**RE: Bareles Commissary Kitchen
1411 South 4th Street SW
Grading and Drainage Plan
Engineer's Stamp Date: 03/01/22
Hydrology File: L14D063**

Based upon the information provided in your submittal received 03/08/2022, the Grading & Drainage Plan is approved for Building Permit. Please attach a copy of this approved plan in the construction sets for Building Permit processing along with a copy of this letter.

A1 SITE GRADING PLAN
1" = 20'-0"

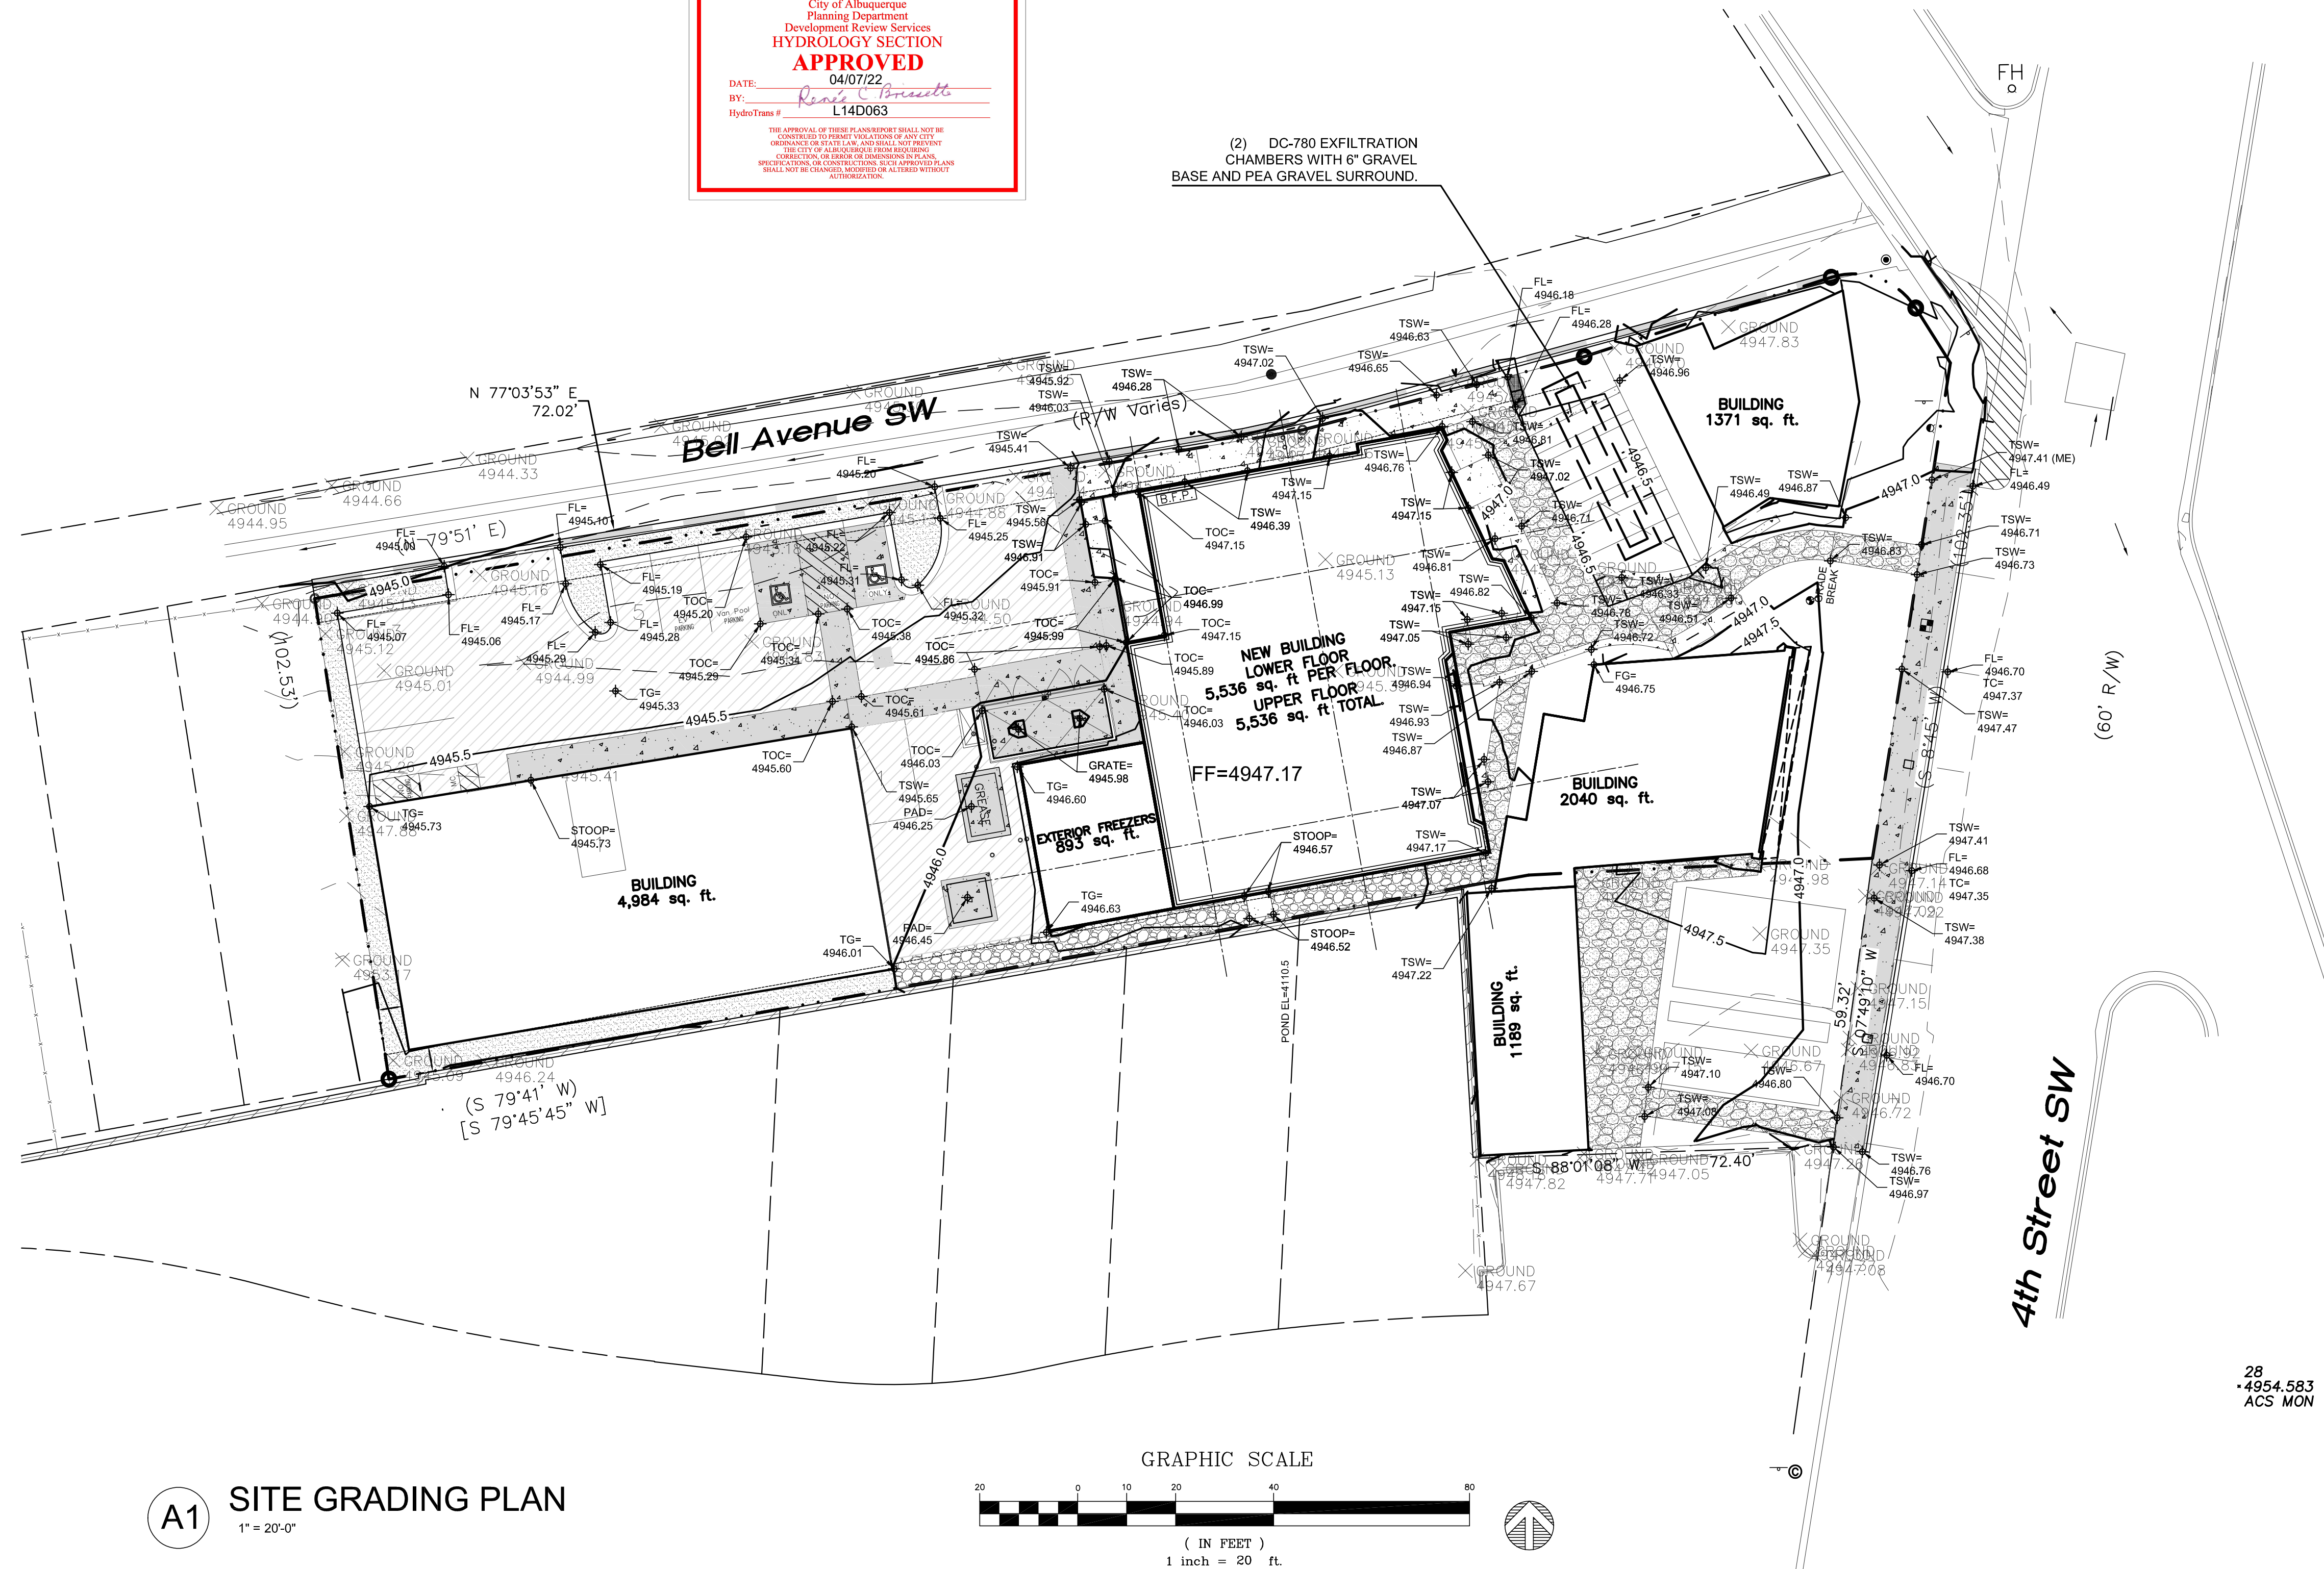
1. Engineer's Certification, per the DPM Part 6-14 (F): *Engineer's Certification Checklist For Non-Subdivision* is required.
2. Please provide the Drainage Covenant with Exhibit A for the underground stormwater quality facility per Article 6-15(C) of the DPM prior to Permanent Release of Occupancy. Please submit the original copies along with the \$ 25.00 recording fee check made payable to Bernalillo County to Marion G. Velasquez (mgvelasquez@cabq.gov) on the 4th floor of Plaza de Sol.
